From: Anna Kramarczyk <Anna.Kramarczyk@midsussex.gov.uk>
Sent: 03 December 2025 13:03:00 UTC+00:00
To: "Katherine Williams" <Katherine.Williams@midsussex.gov.uk>
Subject: RE: DM/25/2283 and DM/25/2472 - Queen Victoria Hospital, Holtye Road, East Grinstead

- **Change the entrance ramp** – the updated design was shown on the submitted Landscape General Arrangement Plan (1442-HUN-XX-00-DR-A-05-0005 P02) I have also attached this for reference. The design has changed due to the updated topographical survey, which provided different spot levels in relation to the ones adopted during the early stages of the design, and up to the planning submission. The external levels around the building, have been adjusted to optimise the access to the new facility, with particular emphasis on the relation between the building entrance and the existing car park, making this levelled access. The design has changed from a dog-leg shape to a straight ramp on the lower part of the site, as well as optimizing the other ramps and stairs that provide access to the new facility. This will benefit wayfinding and disabled access to the building, improving the accessibility to the building in relation to the app

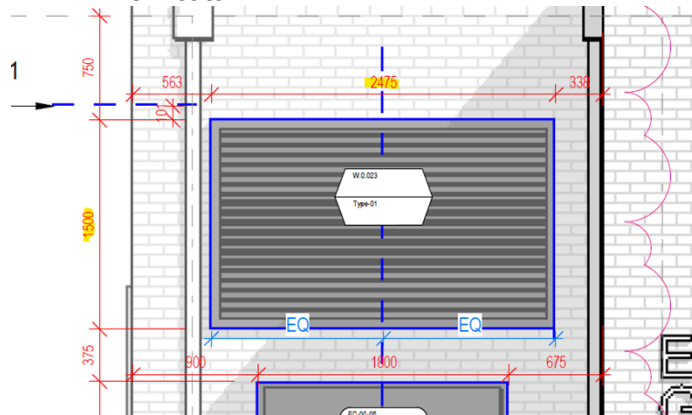
Due to clashes with columns and MEP minimum opening requirements, we are now proposing similar-sized openings for both locations:

- The new updated landscape plan is missing the key for the *Balustrade with Handrail Metal railing installed along the access path, including ramp and stair areas. Powder-coated finish (PPC) in RAL 1019*. Can this be clearly annotated.
- Regarding **Louver design** - *changed due to clashes with the structural grid, identified at detailed design stage. The dimensions of the louvers have changed slightly to accommodate the position of the structural columns and other building fabric elements.* Can I ask to describe 'slightly' in some numbers so I can get a better understanding of the scale of impact of this change.

- **Each opening:** 3.72 m²
- New total:** 7.44 m²
